Standing up for the Warwickshire Countryside

2 September 2019

**Application by Highways England for Order granting Development Consent for M42  
Junction 6 Improvement, Metropolitan Borough of Solihull  
Representations due 2 September 2019 on 'ExQ2'**

## Optional free flow left turns

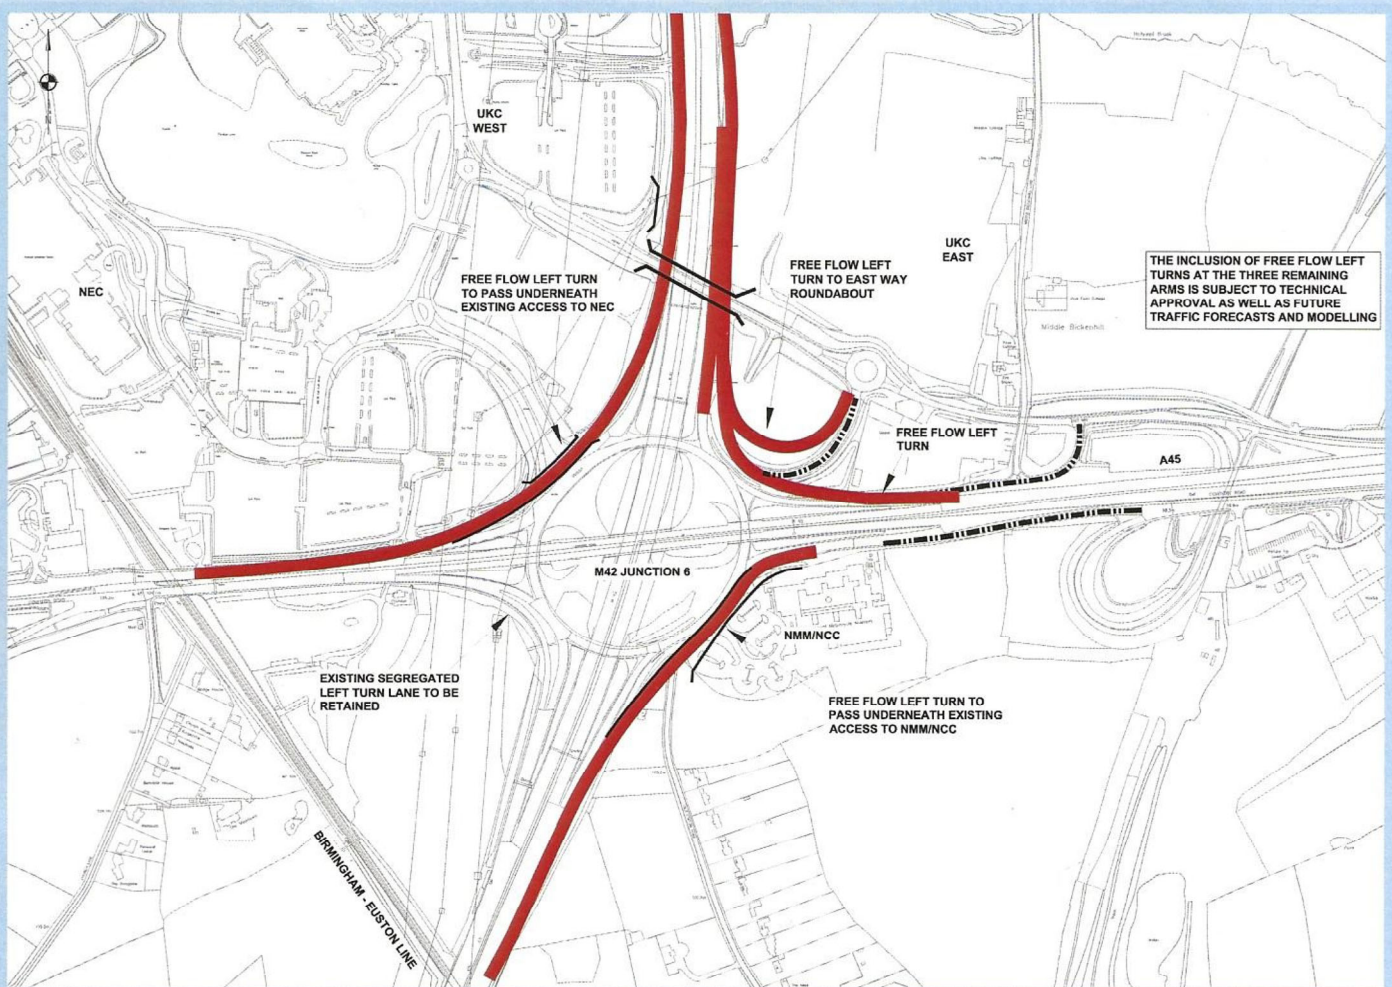
Moreover the proposals before the Examination have changed from those presented for public consultation in December 2016. The 2016 booklet (page 9) (attached extract) showed free-flow links on all four quadrants of the M42 Junc 6 gyratory. But in the NSIP Application one (east-to-south) has been deleted, and one (south-to-west) which exists is proposed to be removed.

It is reasonable that those who participated in 2016-17 should be able to propose that the application have those links included again, and the link road omitted. It was explained on the Site Visit on 4 July that they have been omitted because the link road would fulfil their roles.
